**TRANSPORT AND WORKS ACT 1992**  
**TRANSPORT AND WORKS (INQUIRIES PROCEDURES)**  
**RULES 2004**  
**NETWORK RAIL (HUDDERSFIELD TO WESTTOWN**  
**(DEWSBURY) IMPROVEMENTS) ORDER**

**REBUTTAL PROOF**  
**RELATING TO PROOF OF EVIDENCE KIRKLEES COUNCIL**  
**(OBJ/33)**

*Chris Williams – Highways*

Document Reference	NR/PoE/REB/CW/11
Author	Network Rail
Date	19 October 2021

**Figure 2.4.1: Indicative shared cycling / footway provision**

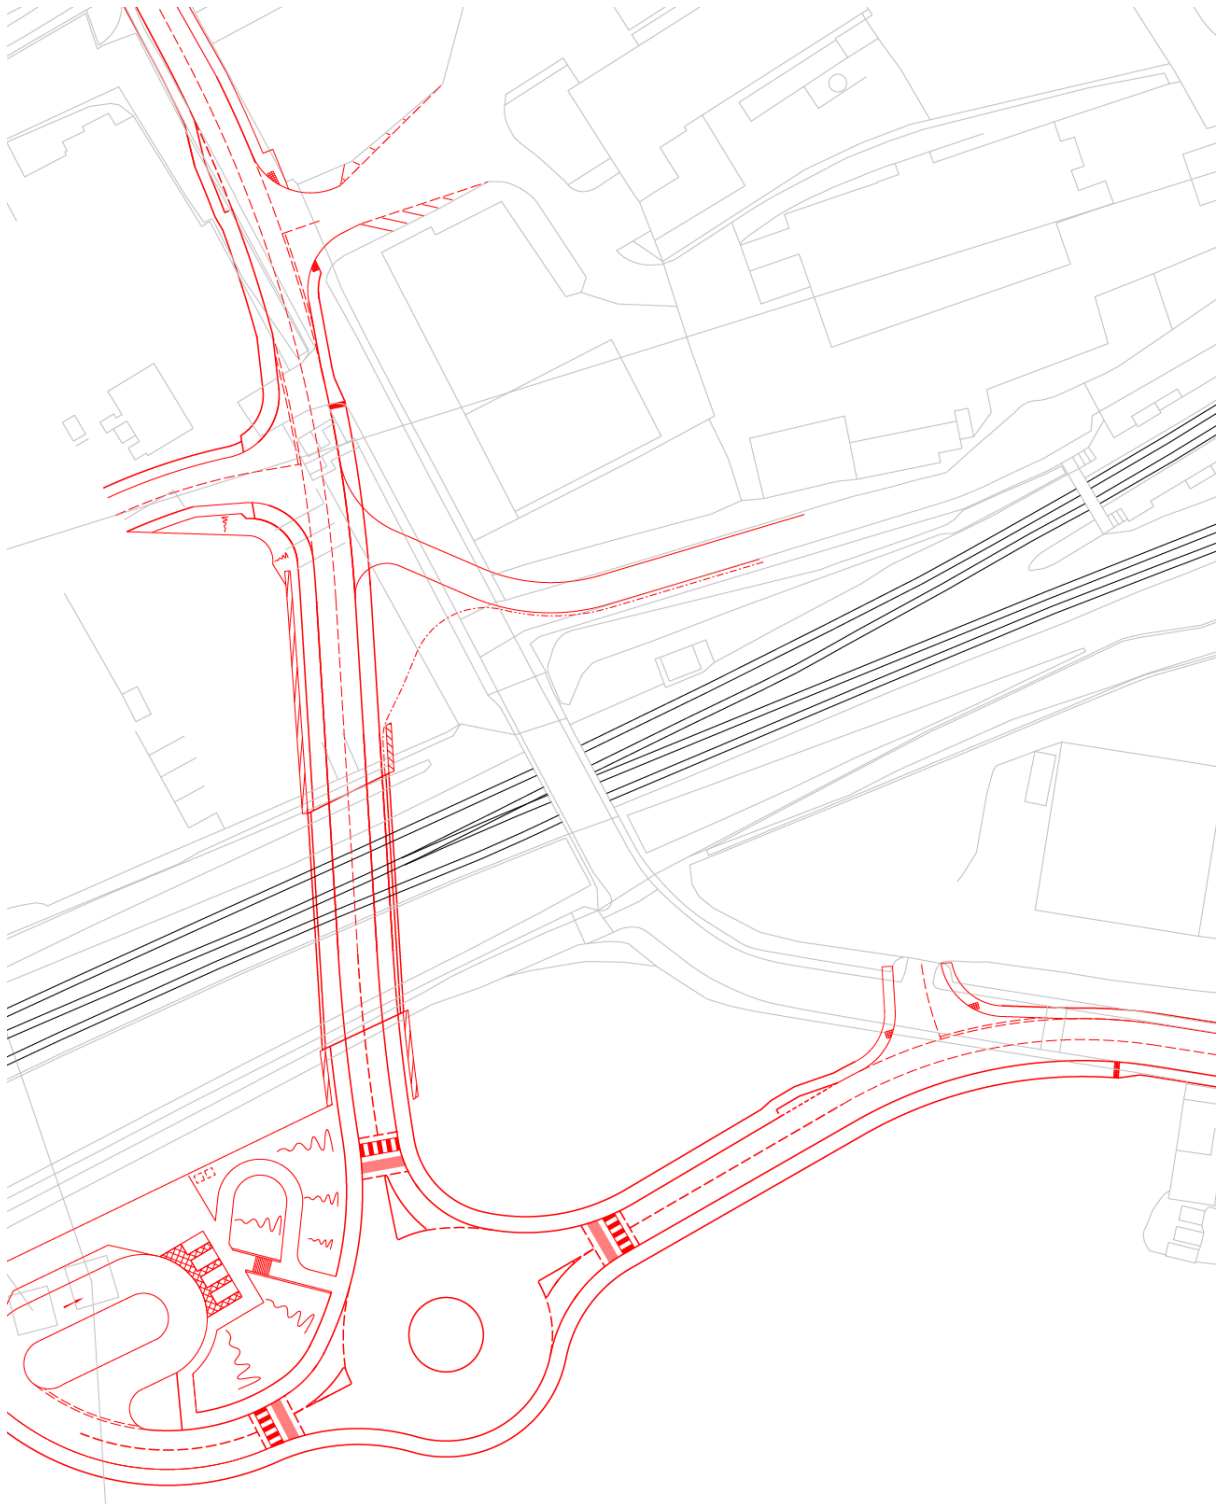
- 2.5.3 The Council's submission also questions the suitability of a normal roundabout in this location and its suitability for cycling and pedestrian connectivity. The roundabout is provided as it enables arms to be tied into the station forecourt, Calder Road and Ravensthorpe Road. Recognising the requirements of LTN 1/20 and Manual for Streets guidance, these documents do not rule out the provision of a roundabout, however, recommend that the provision of a compact roundabout or dedicated cycling provision should be considered.

- 2.5.4 Work is ongoing to review the provision for cycling at the roundabout and this will be discussed in ongoing engagement with the Council. Acknowledging the Council's previous comments and as referenced in my Proof of Evidence, it is proposed to incorporate cycle provision into the design in the form of a shared provision with crossing facilities on each roundabout arm as illustrated in Figure 2.4.1. The extents of shared facilities provided to the north of the railway corridor on Calder Road will need to be agreed to minimise the need for any additional land acquisition from adjacent third-party properties.
